Introduction To enhance front door lock operation and promote water proofing of 1996 and 1997 MY RAV4 door locks, Toyota has added a wire cable door lock plastic shield. The new door lock plastic shield covers the top of the latch mechanism.

Affected Vehicles • 1996 and 1997 Model Year RAV4s.

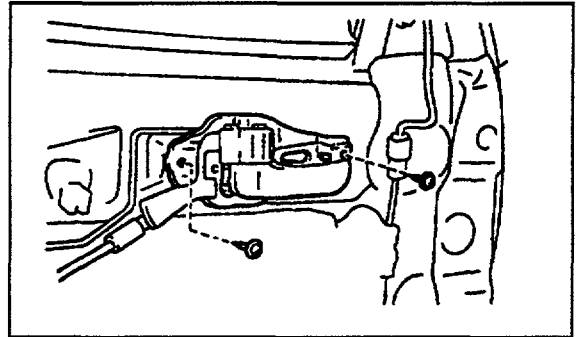
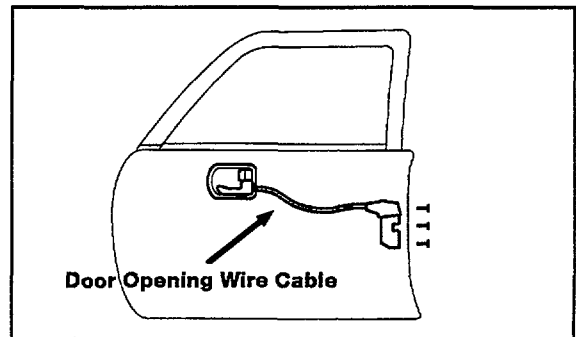
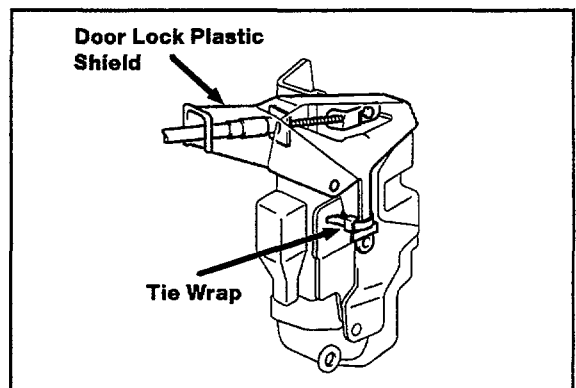
- Door Lock Plastic Shield
- Tie Wrap
- Door Opening Wire Cable

4. Slide door latch mechanism forward to gain access to door opening wire cable end.

5. Replace door opening wire cable.

6. Attach plastic door lock plastic shield using tie wrap.

Removal of the latch assembly is required to install the Tie Wrap and Door Lock Plastic Shield.
